APPENDIX B

The following modifications to the Specific Plan have been proposed since its release in November 1997. These modifications are a result of corrections to the Specific Plan, urban design changes to better reflect a New Urbanist design concepts, and changes recommended to be incorporated due to the staff recommended Alternative.

Following is a summary of the recommended Specific Plan revisions:

Alternative 6
(Hybrid)

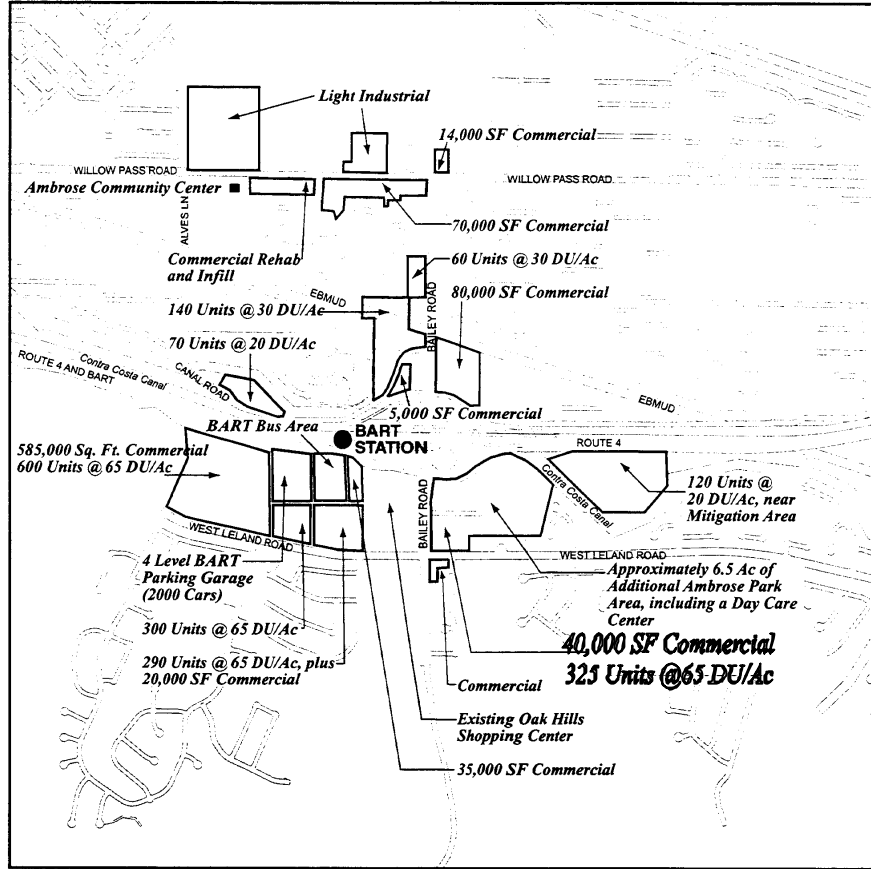
Delete "Alves Lane Road Extension over Highway 4 to West Leland". Replace existing Figure 9 with Figure on following page to reflect staff recommended alternative:

Staff Recommended Alternative (Alternative 6)
Land Use Designations

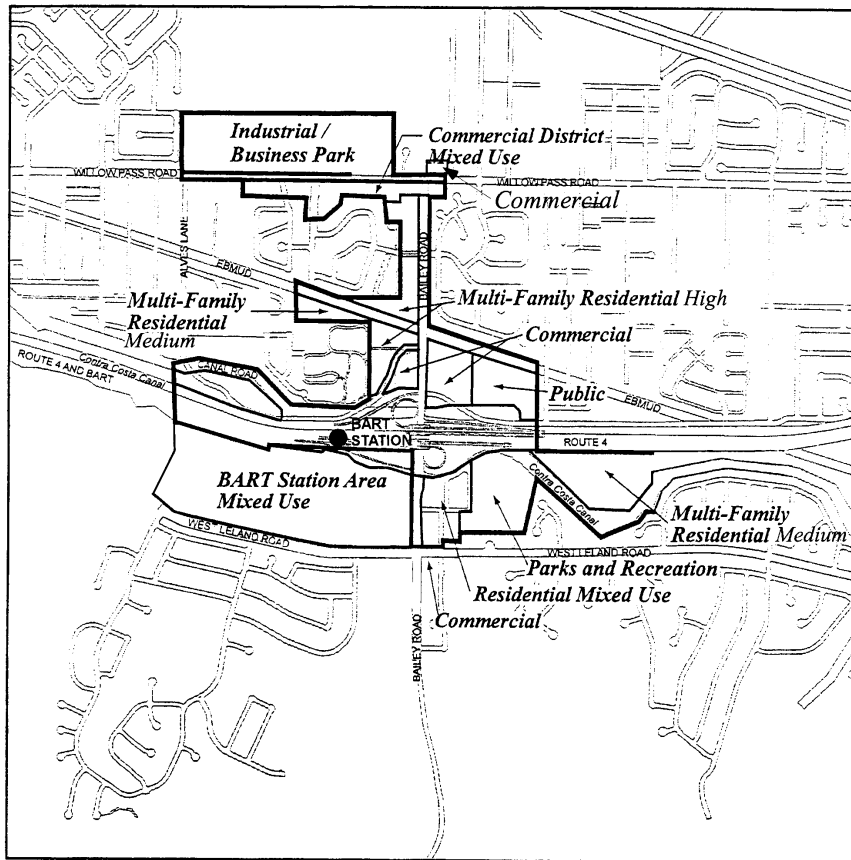
2.12 Figure 10 Replace the existing Figure 10 - Land Use Designation with the following figure to reflect the staff recommended alternative:
